CONTRACT AMENDMENT

**RE: CONTRACT NO.: 20210053R – A-22, A-24, TWIN CULVERTS, BSL-1 AND BSL-2
CONTROL STRUCTURE IMPROVEMENTS
AMENDMENT NO. 2 – ELECTRICAL SERVICE TO A-22 / ADDITIONAL SHEETING -
REVISED**

CONTRACT #20210053R AMENDMENT #2

Contract Title: A-22 / A-24 / Twin Culverts / BSL-1 & BSL-2 Control Structure Improvements

A-22 SITE PLAN

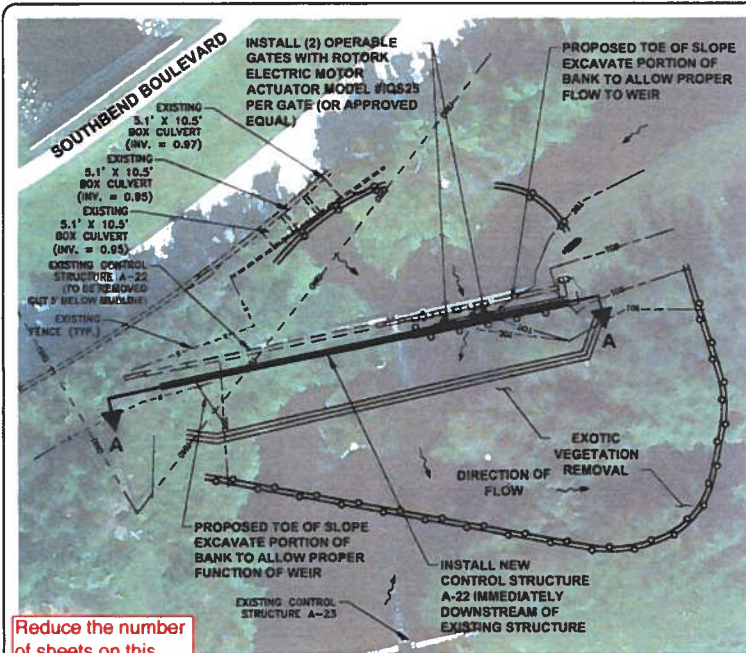
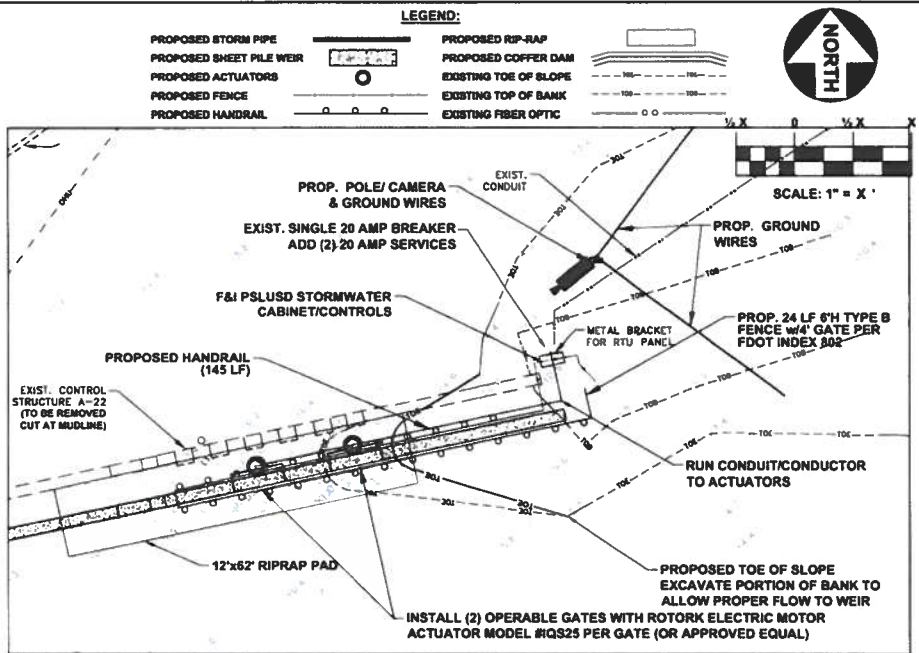
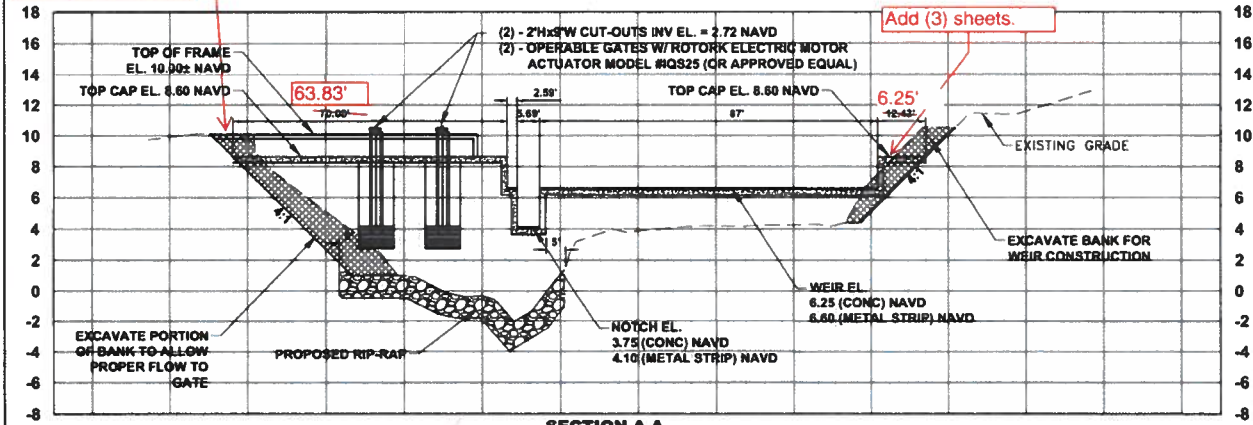
3. Contract Pay Item #999-9 – Sheet Pile Weir. The Plan Quantity for this item was incorrect. The actual quantity for Sheet Piling based on top of sheeting elevation, tip of sheeting elevation and length of weir was actually 3,002.9 SF This result in an over run of 592.9 SF of sheeting. **Increase Cost = \$45,653.30**

DESCRIPTION:
A-22 overrun of new steel sheet pile

SUBCONTRACTORS / VENDORS	SUB / VENDOR WORK DESCRIPTION	AMOUNT:
Custom Built Marine Construction, Inc.	A-22 overrun of sheet pile- 592.9 SF @ \$77/SF	\$45,653.30
